Explanation document for GRSP/2015/16 and GRSP-57-03 for restrain system approval

Current ECE R 16/06 Supplement 5 **Driver seat** Proposed GRSP/2015/16e

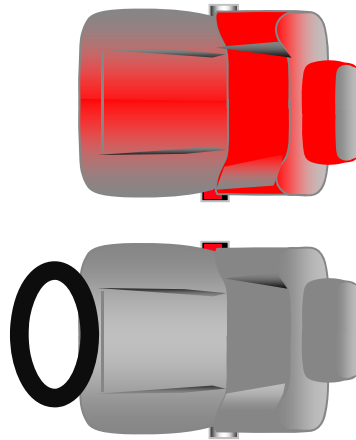
6.4.1.4. ...no part of the torso or the head of the manikin used in the dynamic test would have come into contact with any forward rigid part of the vehicle

7.7.1.5. The seat of an occupant in the front shall be in its most forward driving or travelling position according to the dimensions of the manikin

"6.4.1.3.3. In the case of a safety-belt intended to be used in ~~an outboard front~~ a seating position protected by an airbag ... " *

6.4.1.4.1.2. ...no contact of the head or of the chest with any rigid part of the vehicle in front of the dummy would be allowed, provided contact with vehicle interior does not occur at a speed higher than 24 km/h and no contact of the manikin's head with its knees takes place.

8.1.6.1. ...
Moreover, in that case, the contact of the upper part of the manikin with the interior of the passenger compartment is allowed if the energy absorption requirements defined in Regulation No. 21 ... are fulfilled."

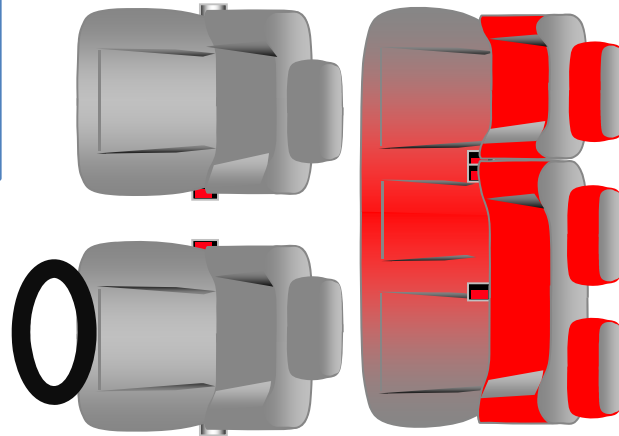
8.1.6. For the front outboard and the front centre seating positions shown in Annex 16 and marked with the symbol *, lap belts of the type specified on that annex shall be considered adequate where the windscreen is located outside the reference zone defined in Annex 1 to Regulation No. 21.

*ECE R 94 Annex IB footnote is today not considering the requirements for biomechanical benefits as tested and assessed today.

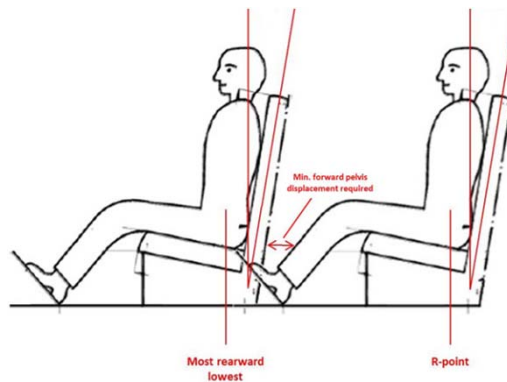
6.4.1.4. ...no part of the torso or the head of the manikin used in the dynamic test would have come into contact with any forward rigid part of the vehicle

6.4.1.3.2.the forward displacement of the manikin shall be between ... 80 and 200 mm at pelvic level ..

6.4.1.4.1.2. ...no contact of the head or of the chest with any rigid part of the vehicle in front of the dummy would be allowed, provided contact with vehicle interior does not occur at a speed higher than 24 km/h and no contact of the manikins head with its knees takes place.

For the assessment of the requirements... the seat of the tested manikin and, if applicable, the seat in front of the manikin shall be considered to be in the positions specified in paragraph 7.7.1.6. below."

"7.7.1.6. For the assessment ... the seat of an occupant in the front shall be in its most forward driving or travelling position according to the dimensions of the manikin. ...

The seat in front of a tested seat shall be adjusted to the most rearward and lowest position appropriate for any contact with the manikin installed on the rear seat, then shifted forward for minimal pelvis displacement according to paragraph 6.4.1.3.2. and with a seat back angle at 10°, as derived from the 3-D H Point machine (Annex 19, Figure 1).

This can be proven with a contour on CAD or drawing."

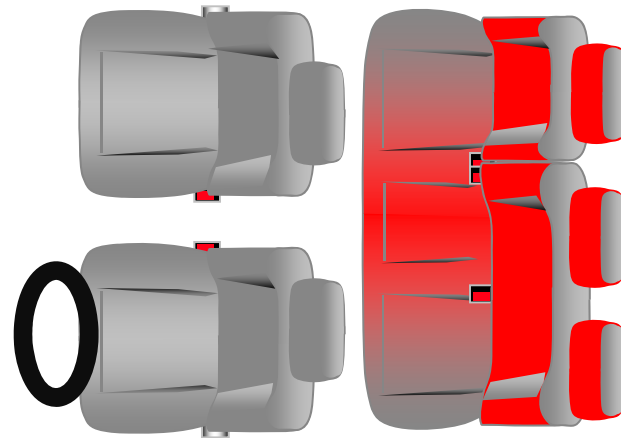
8.1.6.1. For the rear seat positions, if the restraint system .. without the vehicle environment as defined in paragraph 7.7.1., the installation conditions in the vehicle shall be verified for the compatibility with those defined in the Communication form for the approval of the restraint system.

Moreover, in that case, the contact of the upper part of the manikin with the interior of the passenger compartment is allowed if the energy absorption requirements defined in Regulation No. 21 or Regulation No. 17 are fulfilled."
